**Willow/Central Affordable Housing Development
Acton Community Housing Corporation
Acton Town Hall
472 Main St.
Acton, MA 01720
(978) 263-9611
achc@acton-ma.gov**

**SUBSURFACE SEWAGE DISPOSAL SYSTEM
NEW CONSTRUCTION**

**28 WILLOW STREET AND
214 CENTRAL STREET
ACTON, MA**

Comprehensive Permit Plan

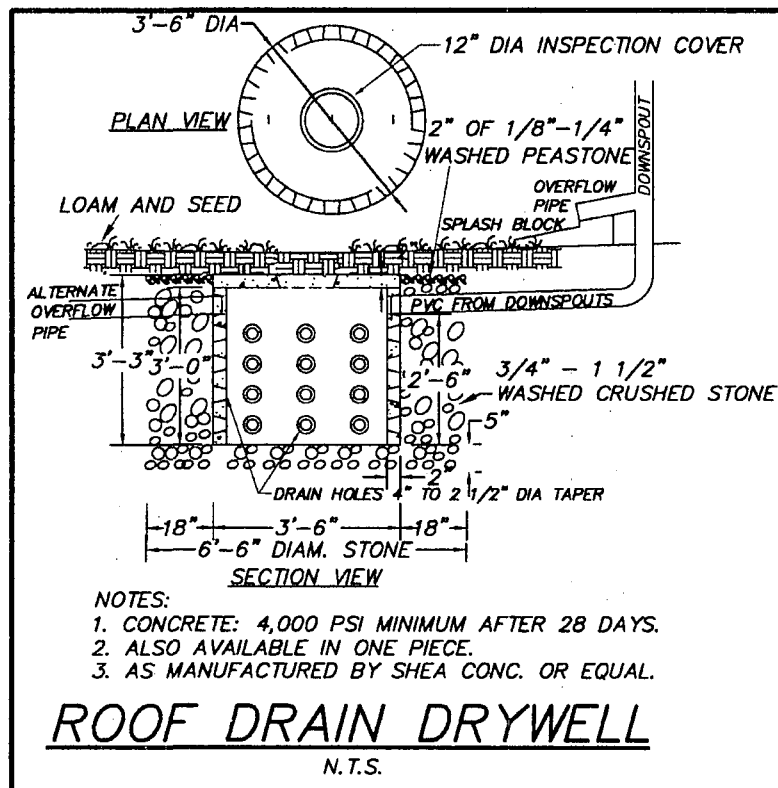
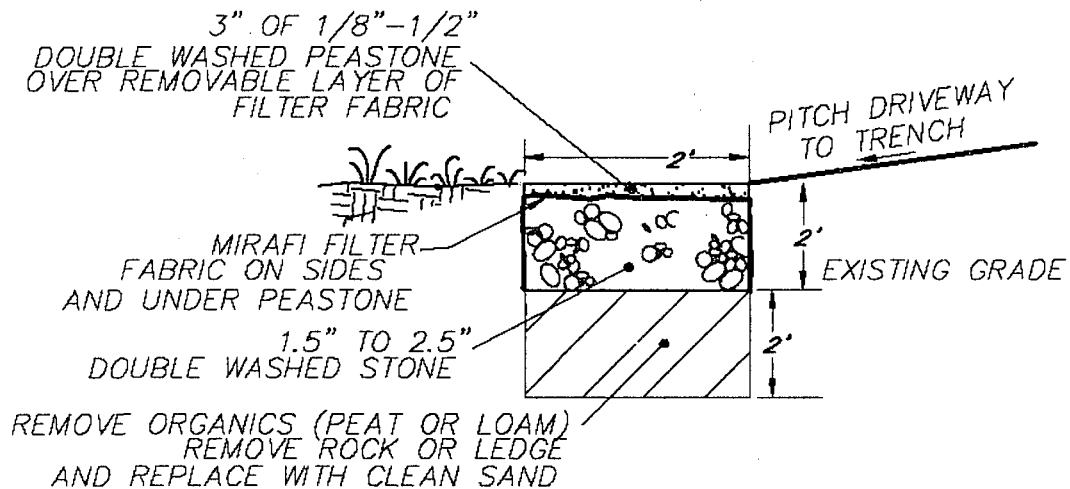
- I would like the description of the roof drywell to explain in more detail how to monitor the water levels in the drywell so that future homeowners understand when this drywell begins to clog. You might want to state the approximate time it will take after a rainfall event for the drywell to completely infiltrate all the runoff and become dry.

- See sheet 2 for revised sidewalk detail.
- Note 12 has been added to sheet 2 and existing survey monuments are now shown
on sheets 1 and 4.
- Note 13 has been added to sheet 2.
- The drainage system operation and maintenance plan has been modified.
